ADDENDUM NO. 1

DATE: February 10, 2015

OWNER: City of Grand Junction

PROJECT: **Las Colonias Park Phase I**

LAS COLONIAS PARK PHASE I STORM WATER PLAN & PROFILE STA 0+00 TO STA 5+00

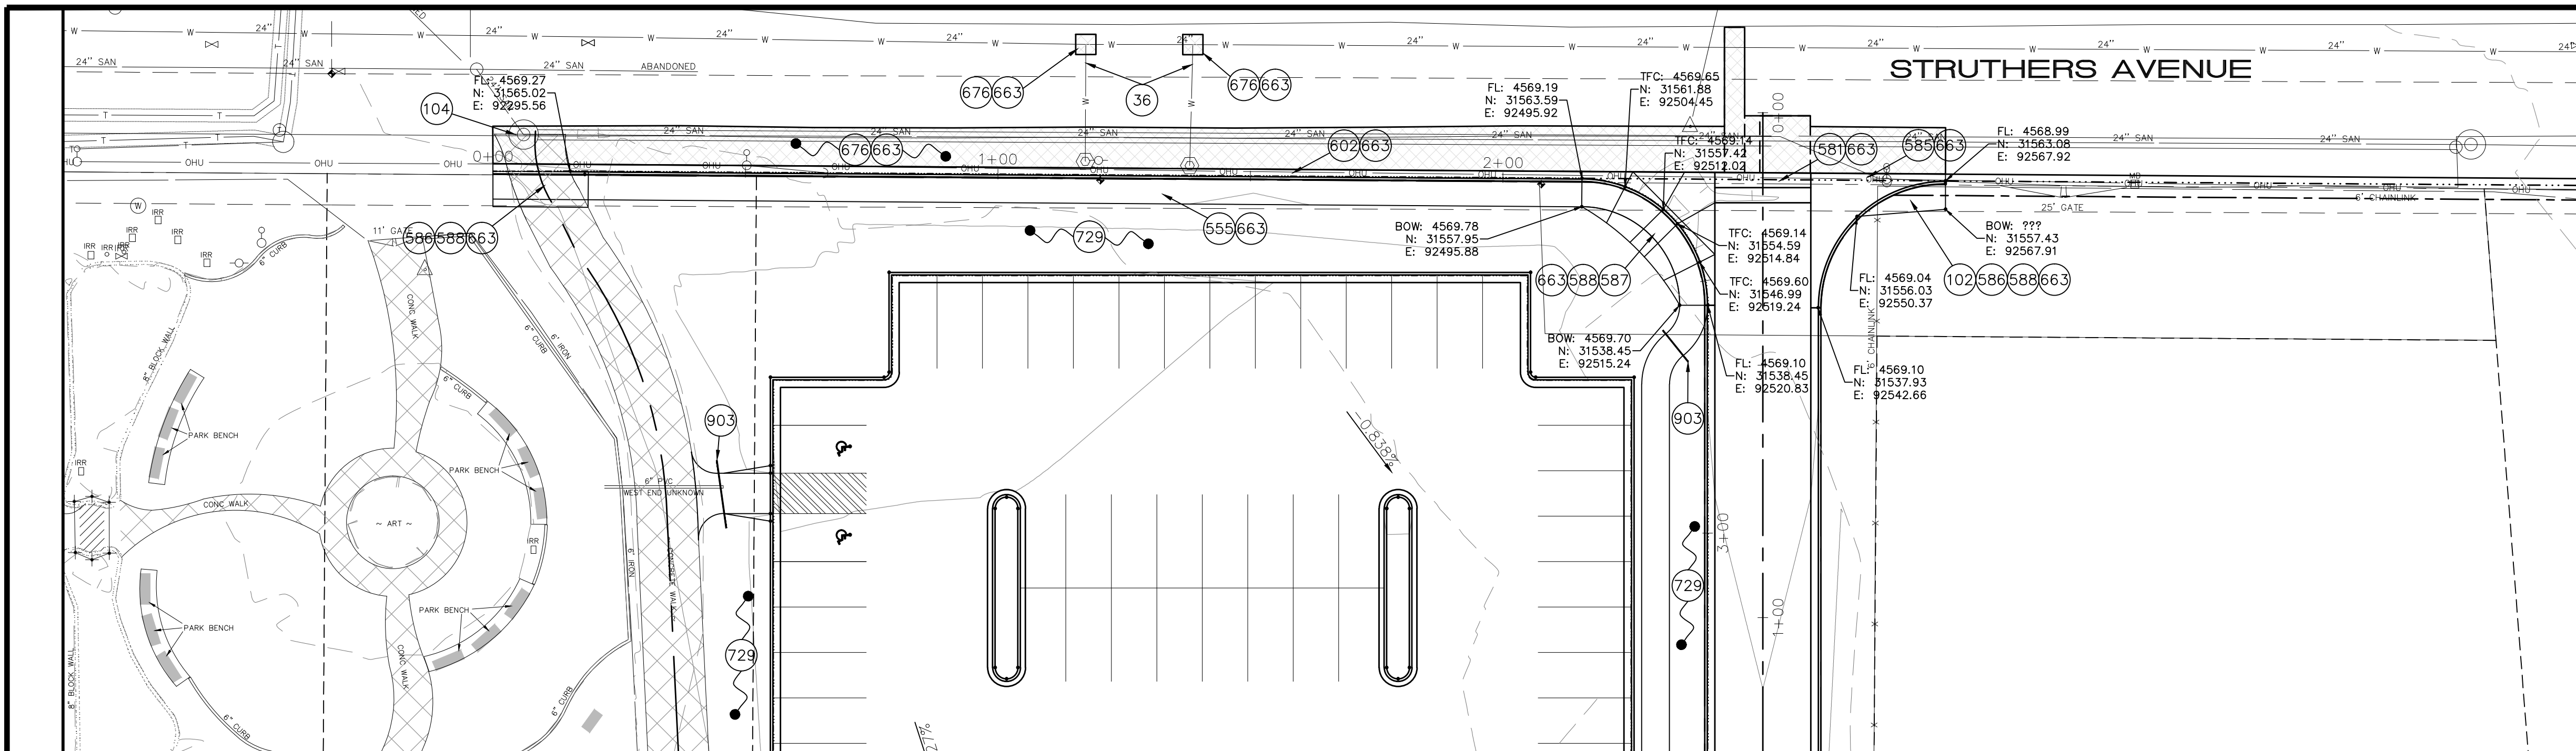
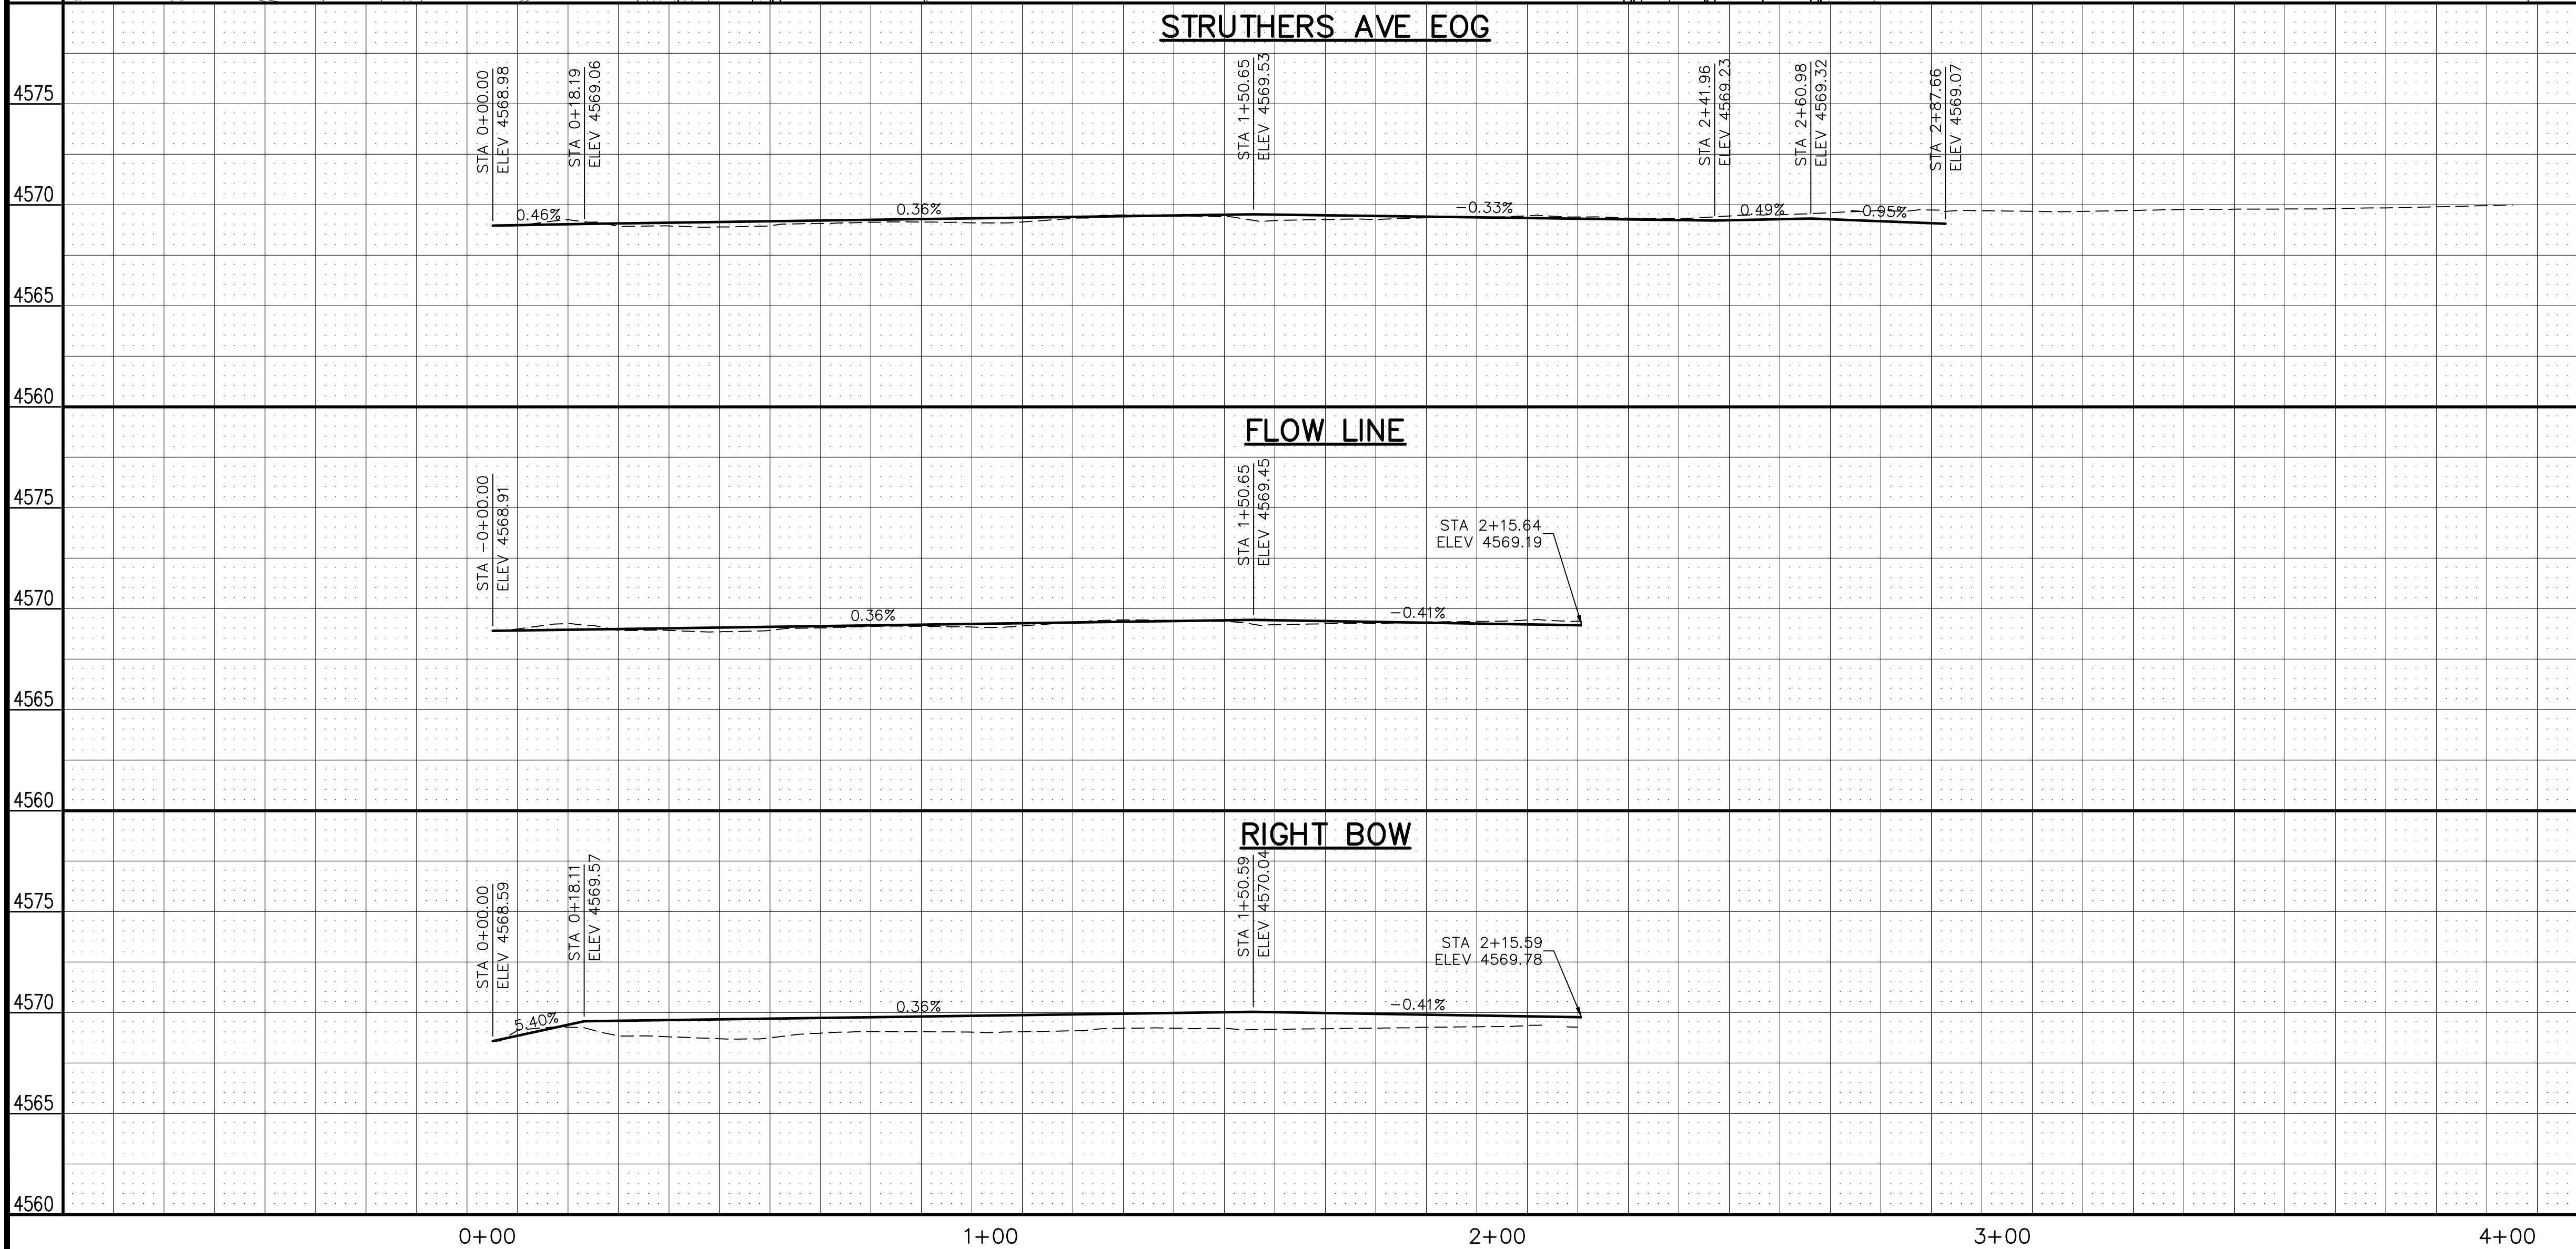
1. **Pre-bid Meeting Agenda and Attendance List** – Add the Pre-bid meeting agenda and attendance list. See attached agenda, item 10 for Questions and Answers.
2. **Bid Schedule** – Bid Schedule items 4, 26, 39, 41, 46 and 47 were revised. See attached revised Bid Schedule noted Addendum No. 1.
3. **Plan Set** - Revisions were made on the Plan Set in regards to the location of the water quality control pond. See attached revised Plan Set noted Addendum No. 1 February, 2015.
4. **Cut & Fill** – Approximate Cut vs Fill (to the bottom of Class 6 Base Course) Quantities for the parking lots and driveway are as follows:
 - Cut (Cu. Yd.) 760
 - Fill (Cu. Yd.) 430
 - Net (Cu Yd.) 340 (Cut)

- Delete Bid Items 26, 39 and 40. The Parks Department will be sodding the pond area following construction.
8. Project specific issues –
- **Discrepancy between Plans Set and Bid Documents** - The Bid Documents and the Standard Contract Documents for Capital Improvements shall take precedence.
